AGENDA ITEM: DFT Project Number: PR-2023-008423

Application Number: SI-2023-00606 Project Name: 4821 Pan American West – Lexus

CODE ENFORCEMENT COMMENTS & APPLICANT RESPONSES

COMMENT RESPONSES IN BLUE BY AYER DESIGN GROUP, BIRKIE AYER, JR., P.E. APRIL 13, 2023

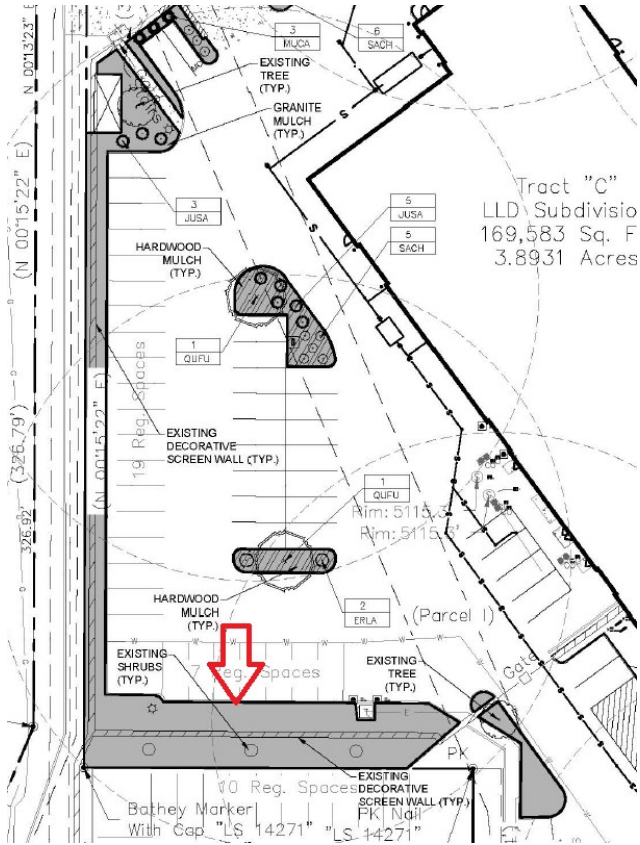
- Replace any dead and or diseased plant materials along the southwest edge of the project.
- Per 14-16-5-6 (C)(5)(e) organic mulch is required as ground cover under trees within a 5-foot radius around the tree trunk, but not directly against the trunk. In these areas, weed barrier fabric is prohibited. **Organic Mulch note is required on the landscaping plan. We recommend the same for the existing trees.**

- **It remains difficult to distinguish between existing and new vegetation. Add existing tree and shrub symbols and numbers to the plant legend. Provide a plan sheet demonstrating the existing vegetative condition.**
AN EXISTING LANDSCAPE PLAN SHEET HAS BEEN ADDED TO SET, SHEET C06.1.

- **Add the plant sizes, coverages and water use for each plant on the plant legend.** In order to comply with 5-6(A)(4) please consider adjusting any plant material if required. You can refer to 'Xeriscaping The Complete How-To Guide' for native/adapted plant palette, sizes and water use.
PLANT SIZES, COVERAGES AND WATER USE ADDED TO PLANT LEGEND, SHEET C06.0.

- **Add vegetative coverage calculations for trees and ground level plants** (14-16-5-6 (C)(2)(c))
VEGETATIVE COVERAGE CALCULATIONS FOR EXISTING AND PROPOSED PLANTS INCLUDED ON REVISED LANDSCAPE PLAN, SHEET C06.0. AND COVERAGE INFORMATION INCLUDED ON NEWLY CREATED EXISTING LANDSCAPE PLAN, SHEET C06.1.

NOTE ADDED TO LANDSCAPE PLAN TO REQUIRE ORGANIC MULCH FOR ALL PROPOSED AND EXISTING TREES, SHEET C06.0.

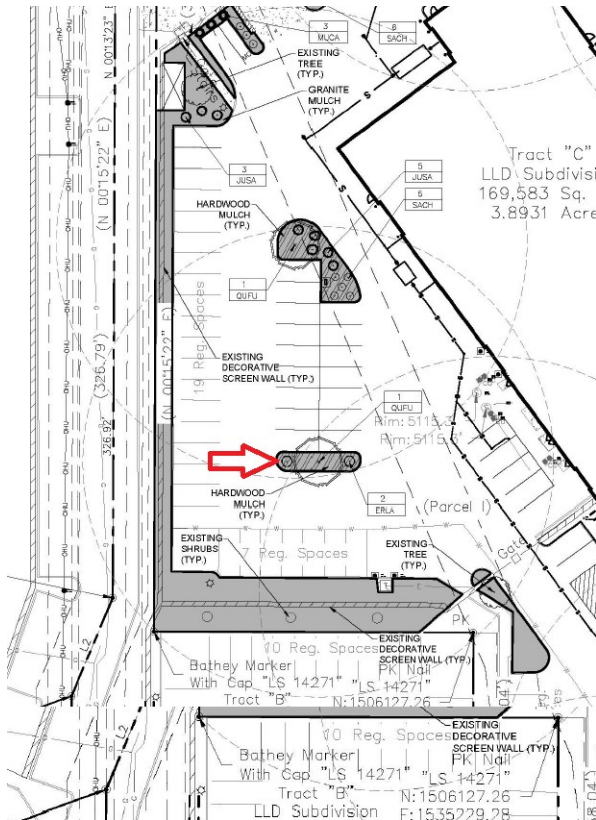
- **Articulate how you comply with 14-16-5-6 (F)(2)(d): The minimum size of tree planters within off-street parking areas shall be 60 square feet per tree.** This requirement may be reduced to 36 square feet if the surface of a parking or vehicle circulation area abutting the tree planter is of a permeable material and, combined with the tree planter area, meets the 60 square foot per tree requirement.

REVISED LANDSCAPE PLAN LABELS TREE PLANTERS, ALL PLANTERS WELL OVER 60 SF., SHEET C06.0.

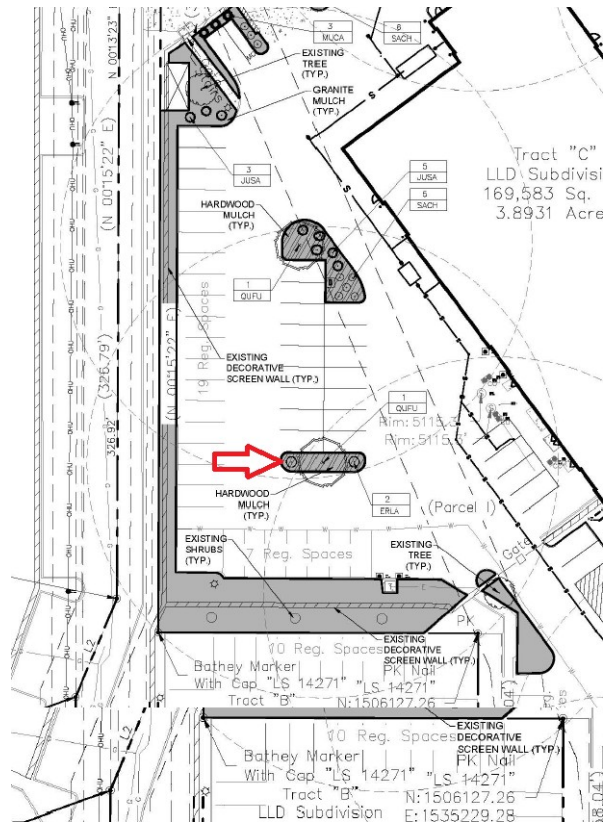
- **Replace any dead and or diseased plant materials along the southwest edge of the project. On the existing landscape plan please specify dead or diseased plant materials (both trees and shrubs) and replacements for them.**

- ✓ **Articulate how you comply with 14-16-5-6 (F)(2)(d): The minimum size of tree planters within off street parking areas shall be 60 square feet per tree.** This requirement may be reduced to 36 square feet if the surface of a parking or vehicle circulation area abutting the tree planter is of a permeable material and, combined with the tree planter area, meets the 60 square foot per tree requirement.
REVISED LANDSCAPE PLAN LABELS TREE PLANTERS, ALL PLANTERS WELL OVER 60 SF., SHEET C06.0.

Landscape Plan and Existing Landscape plan revised to add note for contractor to remove and replace any dead or diseased plant material. One existing dead tree removed from plans, and revised landscape plan shows replacement tree is same general location.
